Ref: FCC Class II Permissive change for FCC ID: XKBIPA280

Applicant: INGENICO

This is to request a Class I permissive change for FCC ID: XKBIPA280
, originally granted on 12/23/2009

New Power Connector for charging by New Cradle/Car Kit

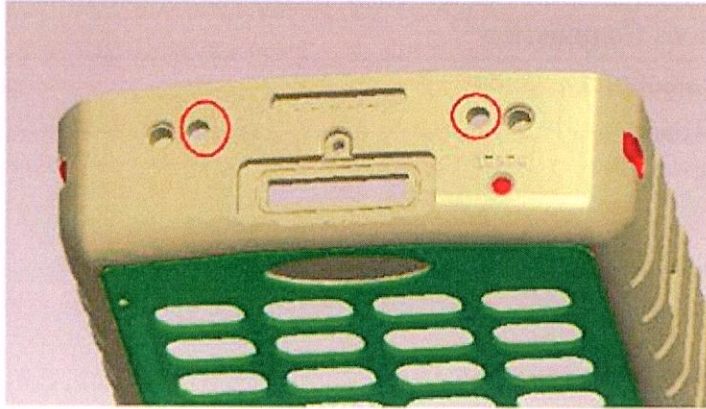
Add two Golden Pin onto the bottom of PDA for charging by upcoming design of PoGo Pin contact on new cradle & Car Kit.

DC Jack for charging by PSU

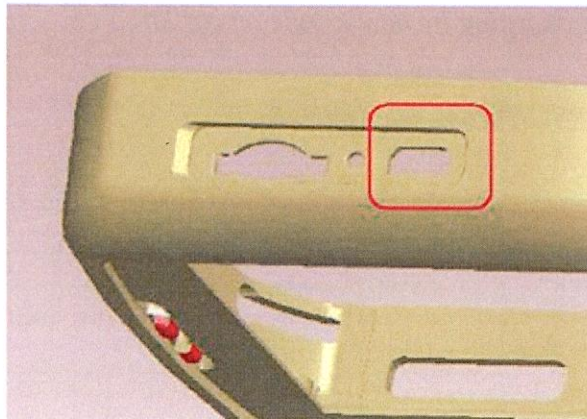
A DC jack is created just next to current Micro SD slot for charging by 5V/2A PSU.
